CHATTAHOOCHEE RIVERLANDS GREENWAY STUDY

SUB-AREA COMMITTEE MEETINGS SUMMARIES AND DIGITALLY SUBMITTED COMMENTS

SUBMITTED ON 11/5/2019

MAP L-100: ALIGNMENT ALTERNATIVES SUMMARIZED NOTES

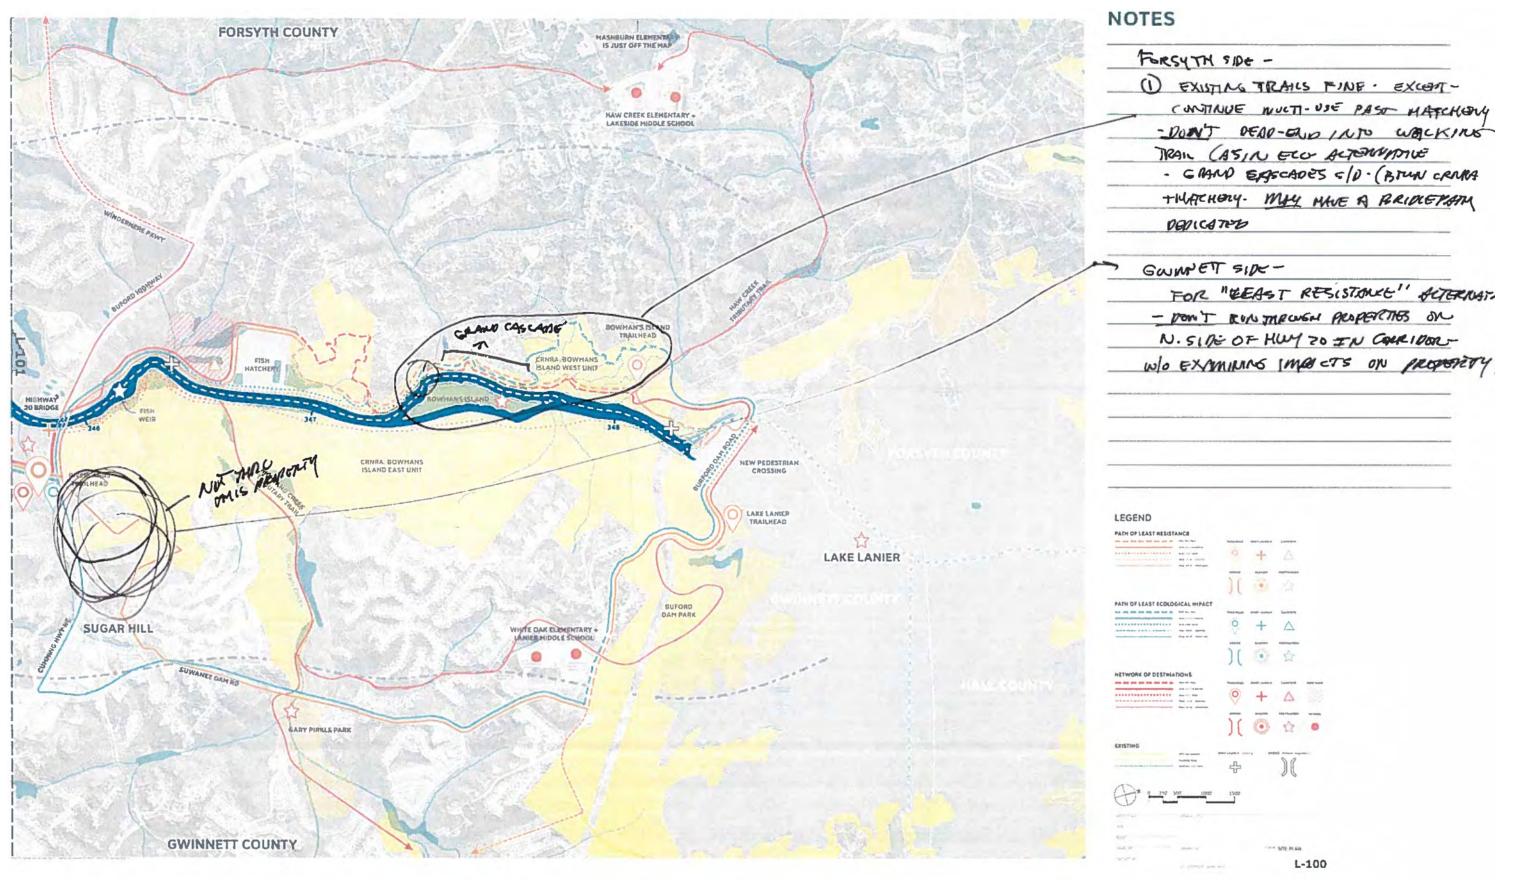
- Trail can go north, but don't advertise / brand as RiverLands until South of Bowman's Island
- NPS will not allow multi-use trail or campsite through Bowman's West, newly acquired land, or fish hatchery

- Preference for trail near/around dam, on East side of the river.
- NPS has not determined alignment of footpath on Bowman's East yet
 - Best to avoid Bowman's East and use Suwannee Damn road

- Suggestion to utilize Sugar Hill gold course
- On Gwinnett Side (East), for Least Resistance Alternative – don't run through properties on the North side of Hwy 20 without examining impacts on the property.

- See Gwinnett comments for alternative alignment that ties into Sugar Hill greenway
- Concerns about SR 20 Bridge very little room for a trail and a moderate risk for peds/cyclists according to ARC

- USACE has offered free access across their property on the east of the river to Bowman's Island East.
 - Use existing bike lanes down from Buford Dam

MAP L-101: ALIGNMENT ALTERNATIVES SUMMARIZED NOTES

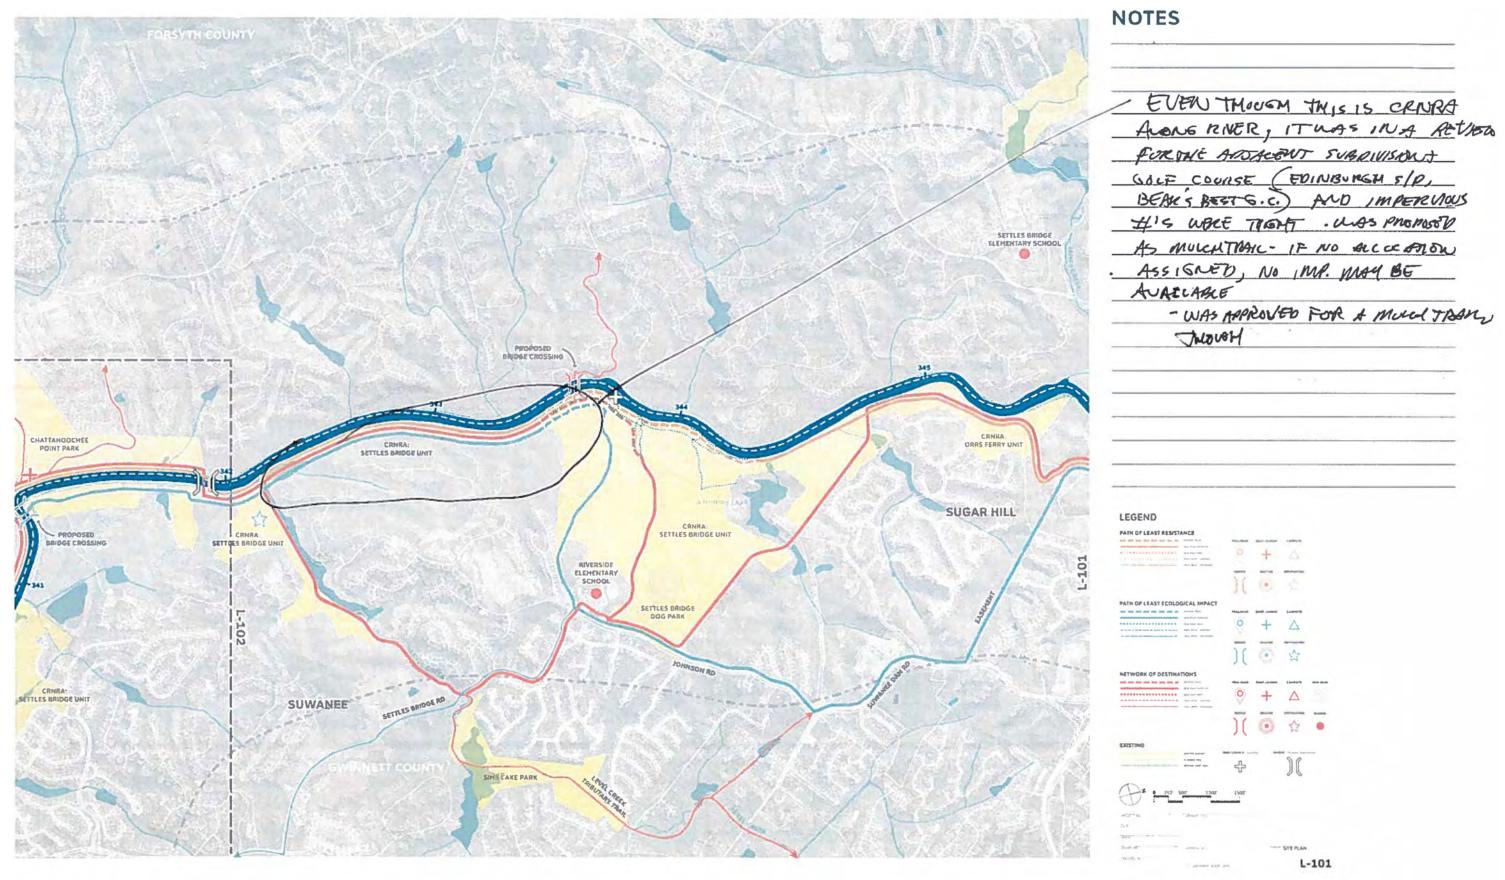
- NPS supports Path of Least Resistance with addition of potential trail along utility easement through Settle's Bridge as well.
- Proposed bridge to from East side to Chattahoochee Point Park makes a lot of sense
 - But need to move/shift bridge away from private property near 342 (to green/park area)
- NOD alternative through Settles Bridge could makes a lot of sense
- Level Creek Tributary trail is already established and well used – could be improved

MAP L-102: ALIGNMENT ALTERNATIVES SUMMARIZED NOTES

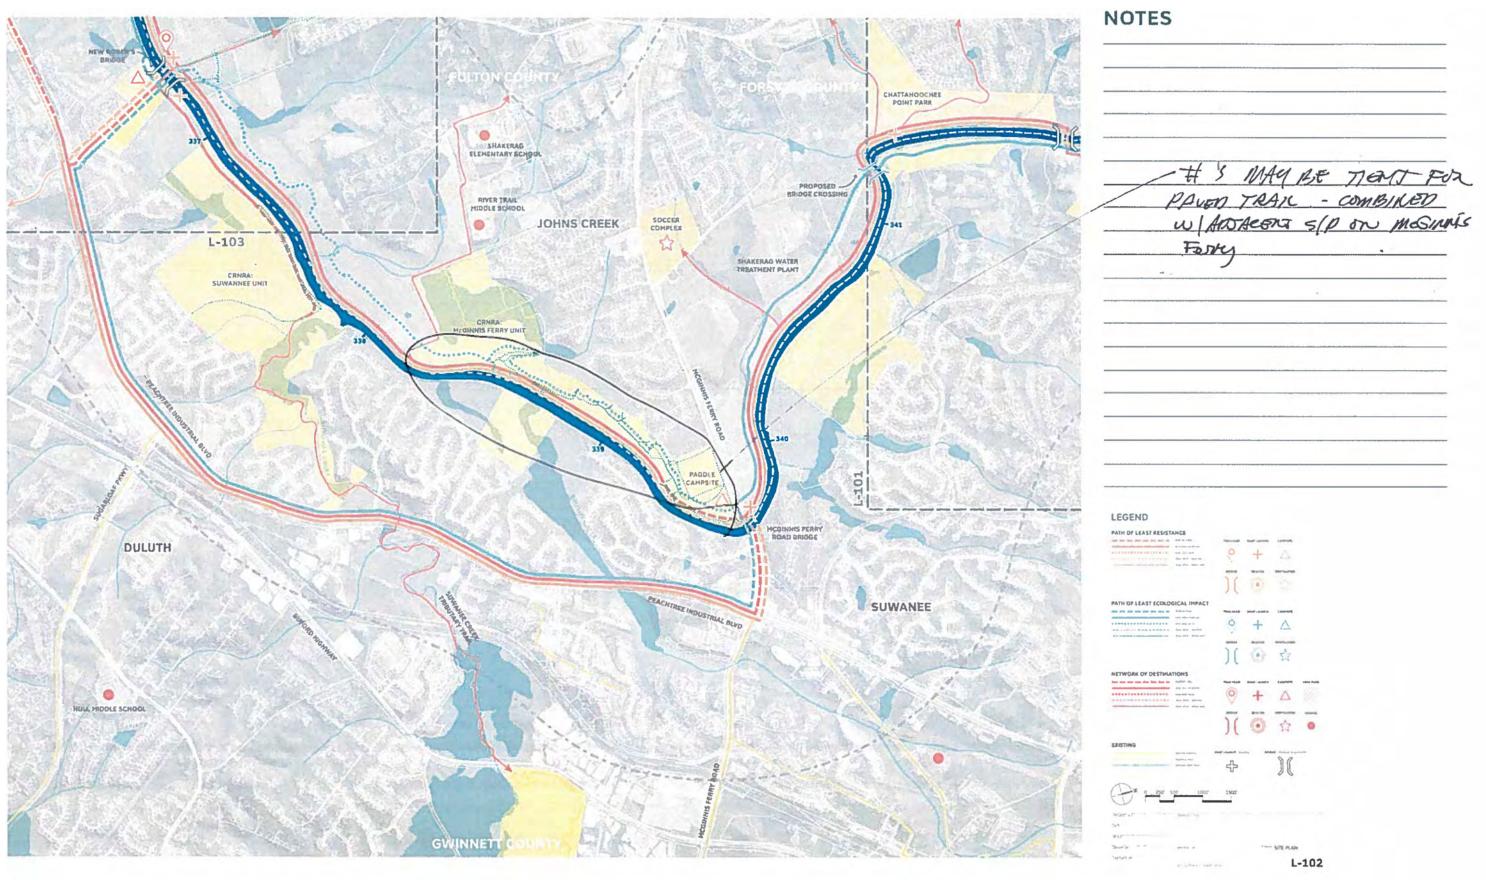
- NPS supports path of Least Resistance alternative
 - No camping at McGinnis FerrySuwannee Unit instead
 - Smart to have an alternative greenway along Peachtree Industrial
 - Avoid trails through Suwanee Creek Unit because of proposed paddle camp
- Seems like it would be difficult to get a trail on the river on McGinnis Ferry Rd
- Add in City of John's Creek Shakerag Park

MAP L-103: ALIGNMENT ALTERNATIVES SUMMARIZED NOTES

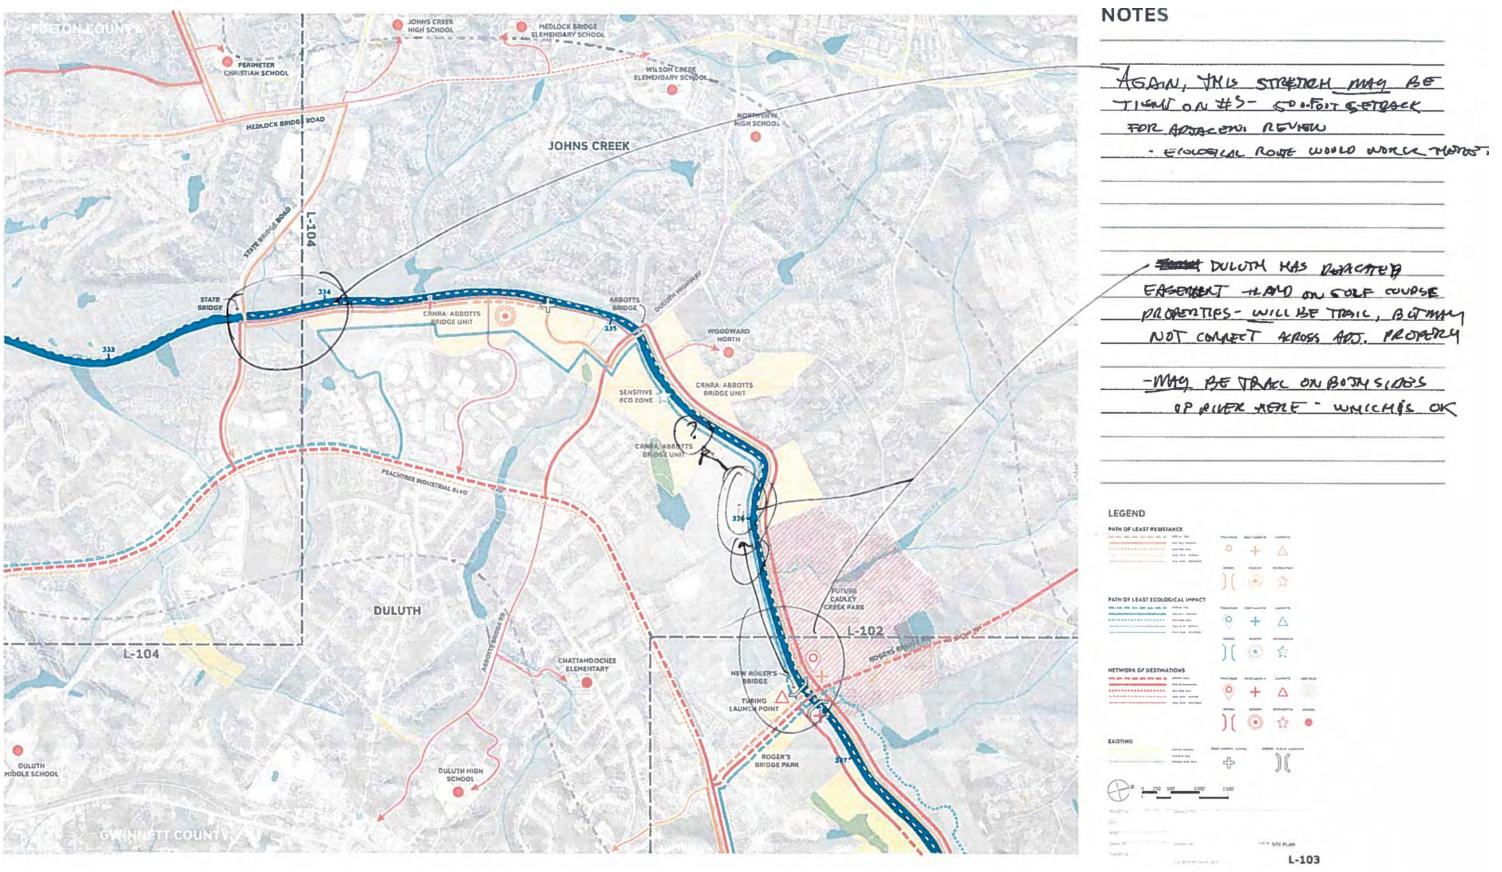
- NPS supports Eco Alternative through Abbott's Bridge SE and Path of Least Resistance to the North
 - Consider pulling greenway back to go adjacent to open field and not River's edge in Abbott's bridge Unit SE

- In Abbott's Bridge Unit NW trail should follow utility corridor (not River's edge).
- State Bridge Road and Medlock Bridge Road are very busy – would need a substantial buffer to put trail along these roads

- City of Johns Creek suggests showing bridge over Cauley Creek and perimeter loop trail around the future Cauley Creek park
- Eco Alternative may work better to avoid MRPA concerns in the Abbott's bridge unit

- Duluth has a dedicated easement on golf course that will be a trail, but may not connect across adjacent properties.
 - A trail on both sides of the river here may be ok

- Gwinnett notes that on the East side of the river, opposite future Cauley Creek park, there is potentially 8-10 acres being dedicated by Duluth

MAP L-104: ALIGNMENT ALTERNATIVES SUMMARIZED NOTES

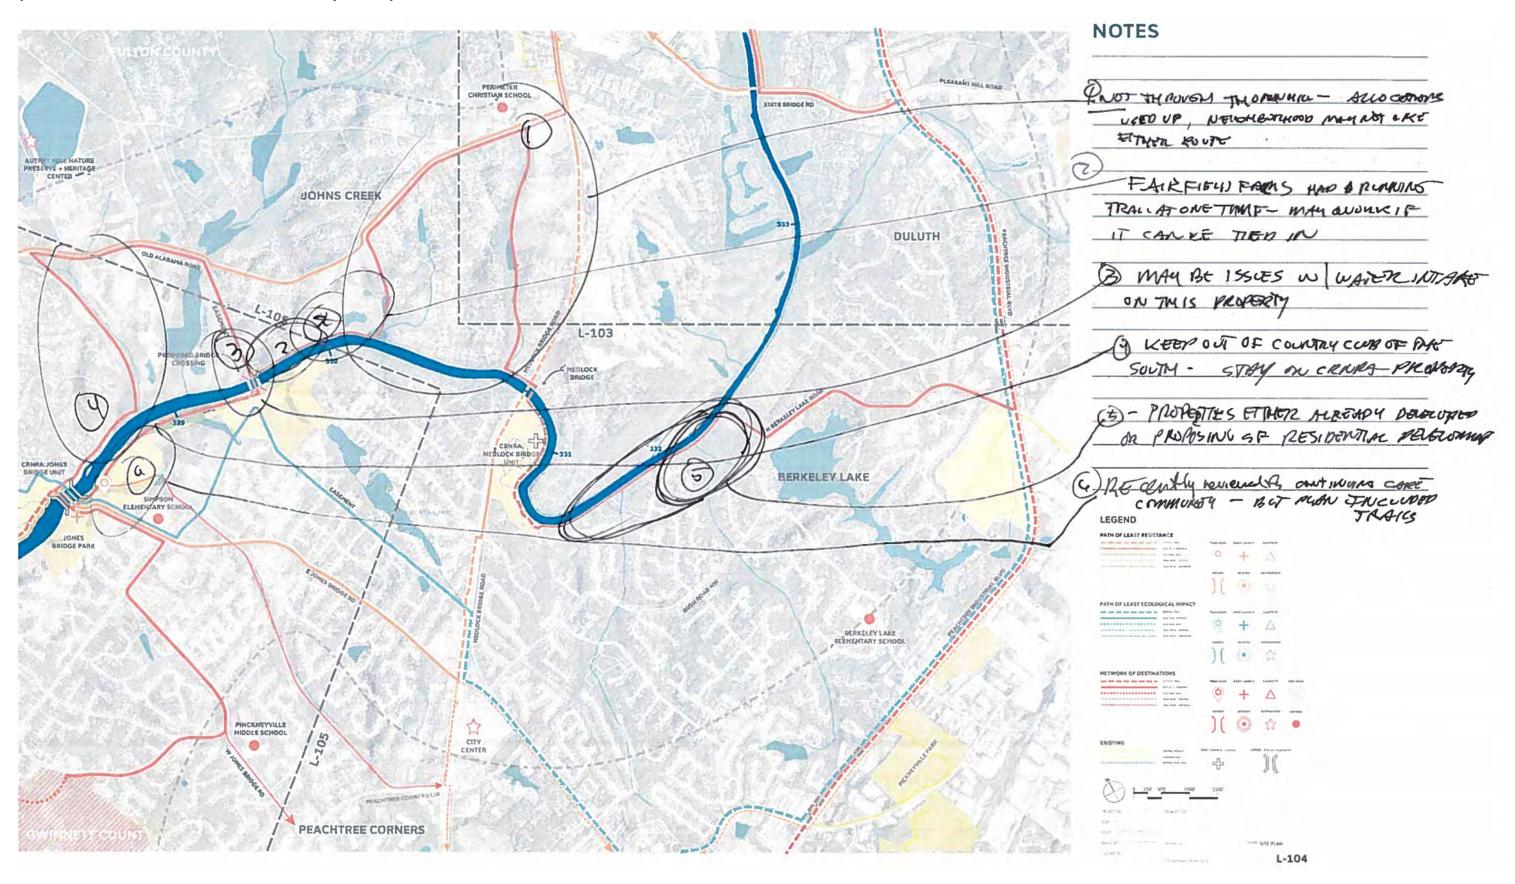
- NPS is supportive of a proposed bridge @ Jones Bridge
 - Potentially could cross at NOD alternative bridge as well
- Old Alabama Road makes sense
- Suggests going along river between Medlock and Jones Bridge
 - Utilize easement rather than E Jones Bridge Road (Eco Alternative)
- Might want to consider utilizing gold courses (between State Bridge Road and Medlock on the North side of the river)
- NOD alternative is too convoluted / has several serious ownership issues
- Gwinnett County emphasizes connection to city center along E Jones Bridge Rd

MAP L-105: ALIGNMENT ALTERNATIVES SUMMARIZED NOTES

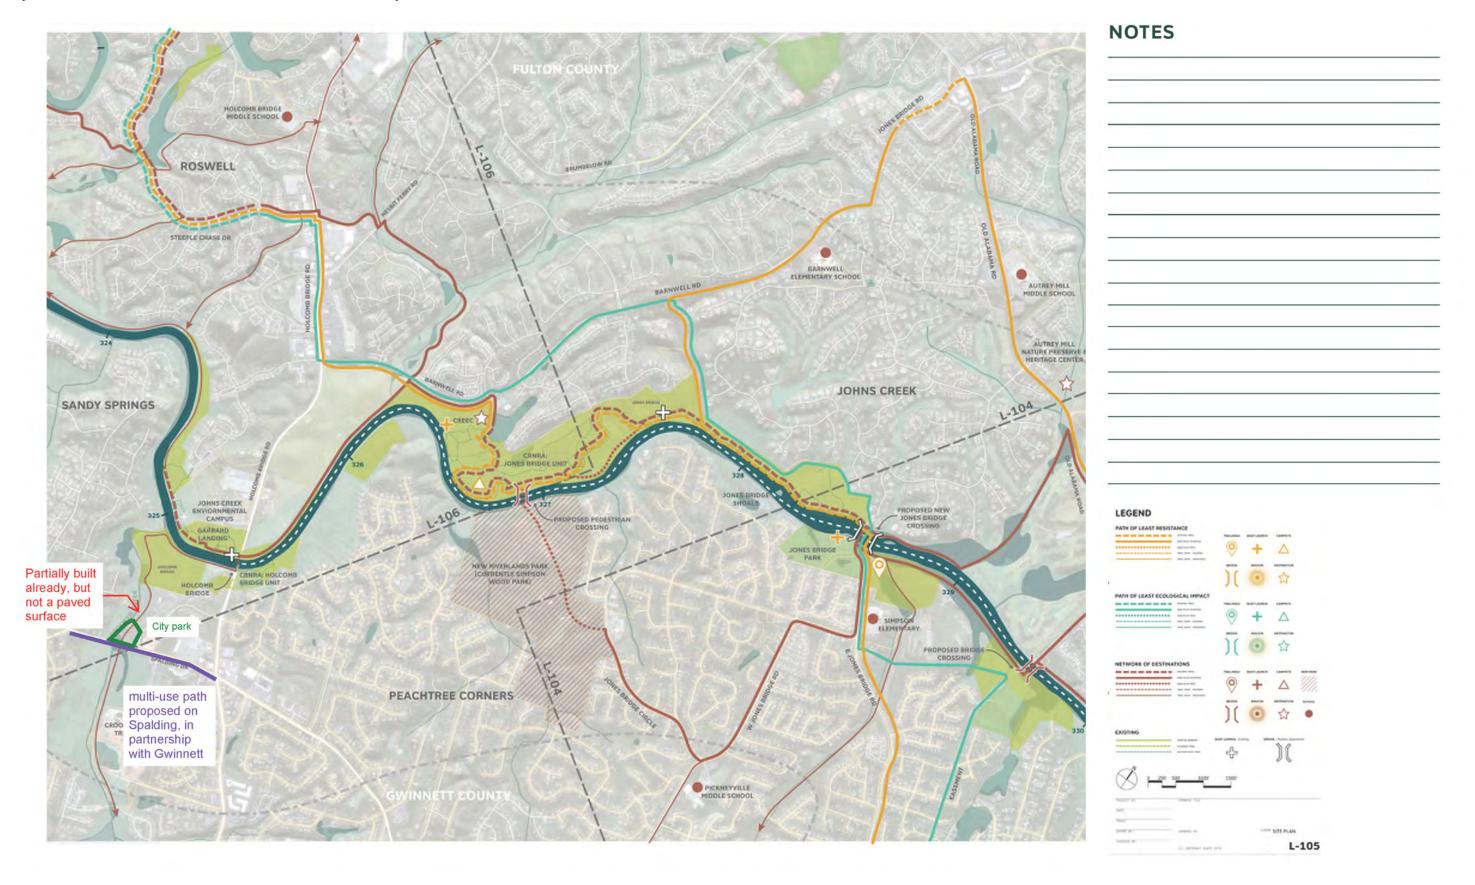
- NPS recommends Eco Alternative, at least past CREEC
 - Using Barnwell Road, rather than going through the Jones Bridge Unit
 - Eco alternative that runs close to the river North of the Boat launch, using road and utility easement is ok
 - Can't continue south of boat launch due to terrain and property ownership
- Recognize multi-use path proposed on Spalding, in partnership with Gwinnett (near Crooked Creek)
- NOD alternative is a total no-go

MAP L-106: ALIGNMENT ALTERNATIVES SUMMARIZED NOTES

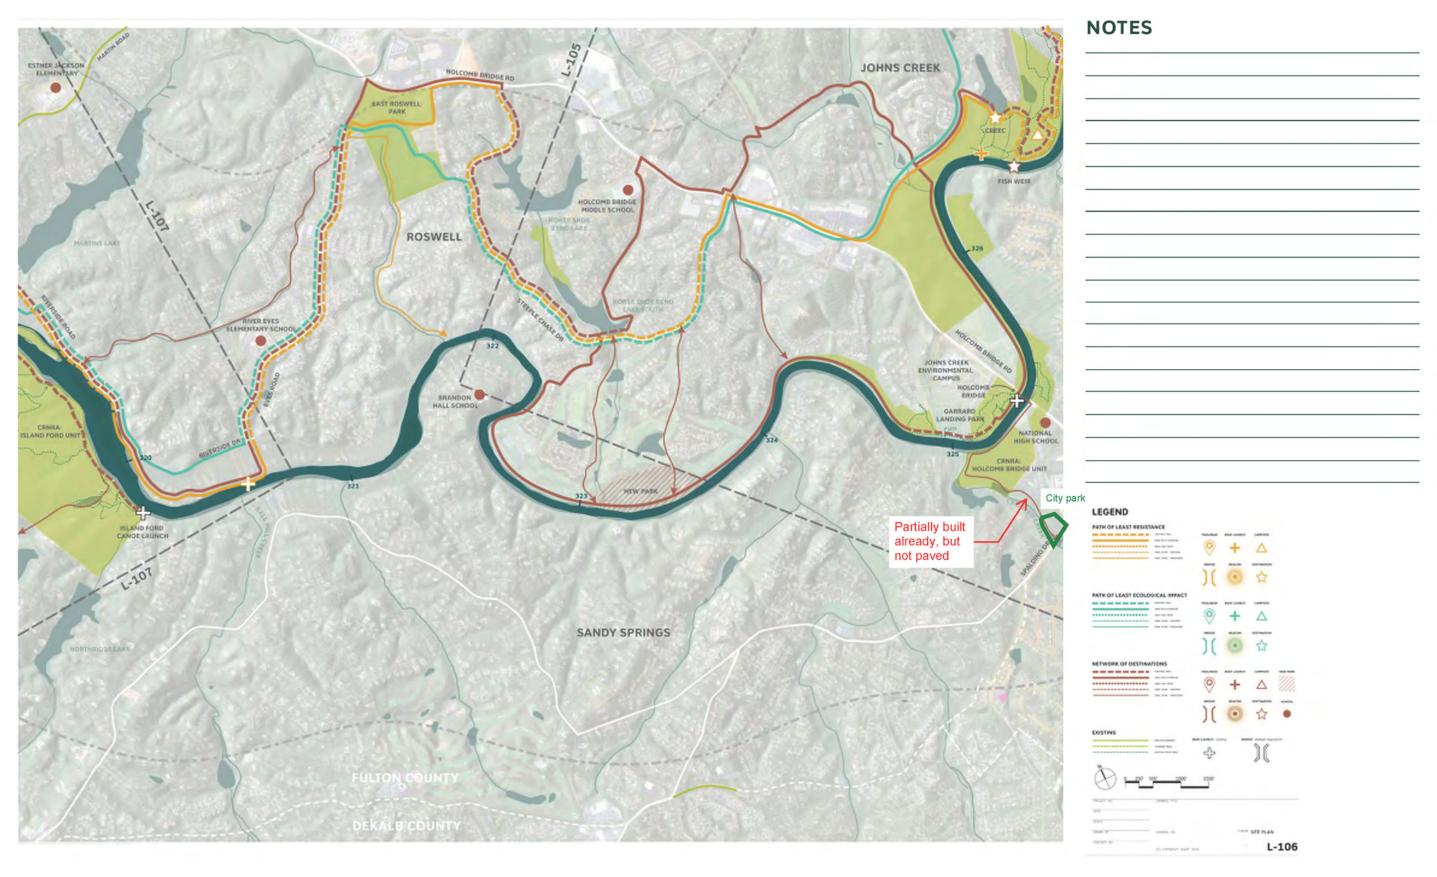
- NPS prefers ECO option
 - Recommends removing all alignments through CREEC, Holcomb Bridge Unit and Island Ford
- Holcomb Bridge Road is busy and fast – try to avoid
- NOD path along the river on West side goes through a lot of private backyards
- May want to look into a crossing opportunity from Riverside Road, through Island to Island Ford Unit
